LIST OF CHANGES (LOCATIONS AS LABELLED)

London School Of Hygiene & Tropical Medicine

Drawing issue for Section 96a Planning Submission

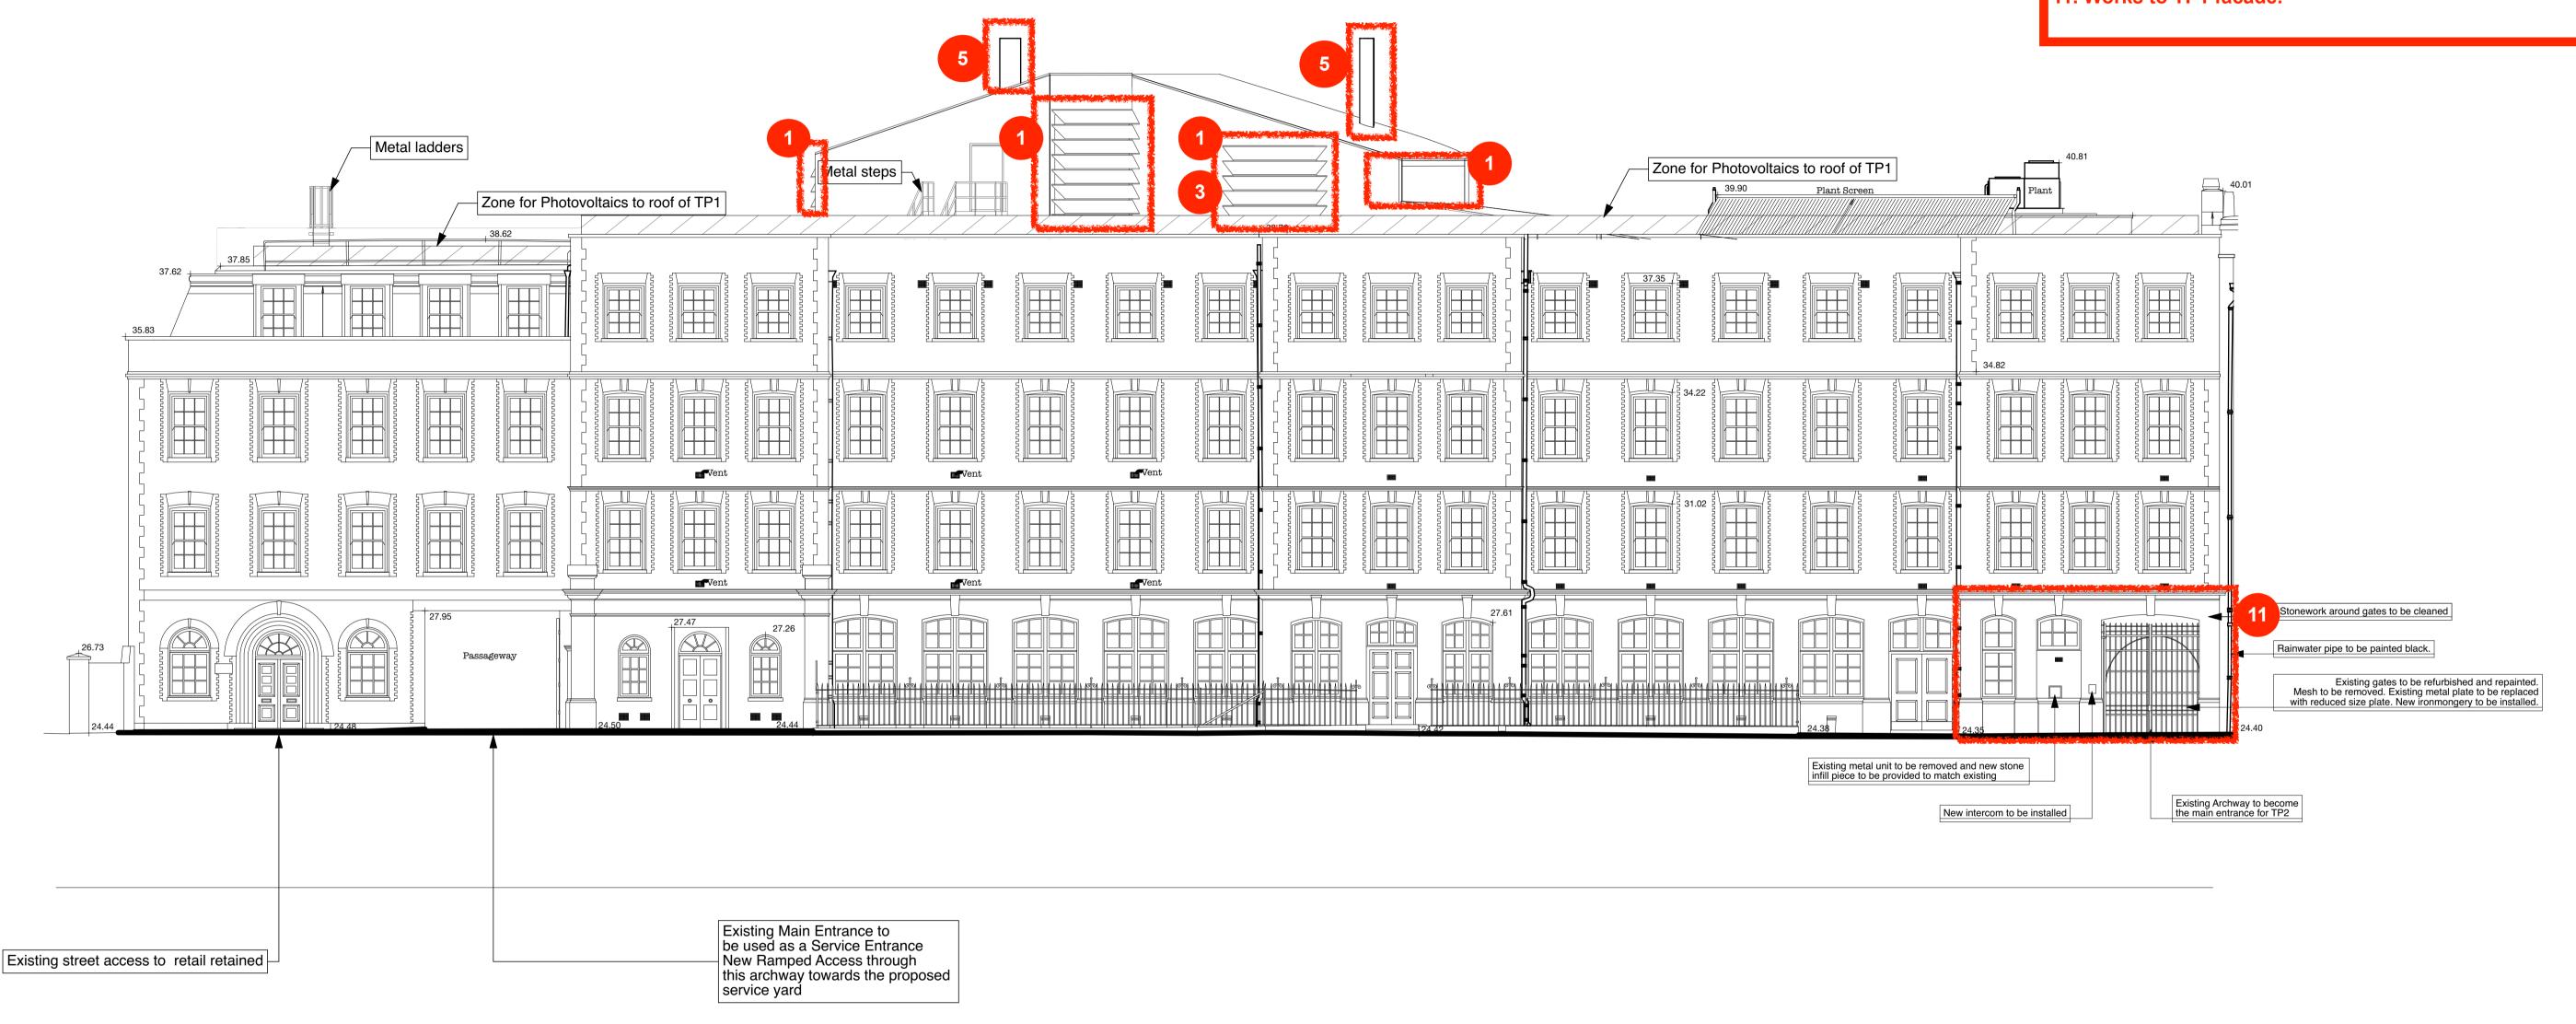
- 1. Louvre design and arrangement updated, Level 4.
- 2. Louvred vent added to Gas Meter Room, Level 0.
- 3. External access doors to plant room omitted, Level 4.
- 4. External plant equipment added, Level 0. 5. Flues revised, Roof level.
- 6. Roof openings & access hatch added/revised, Roof
- 7. East entrance passageway levels revised, Level 0.
- 8. East entrance passageway and Stair 3 works revised.
- 9. Relocation of cycle parking and bin store, including canopies, Level 0.
- 10. Car charging points added and parking bays adjusted to suit, Level 0 courtyard.
- 11. Works to TP1 facade.
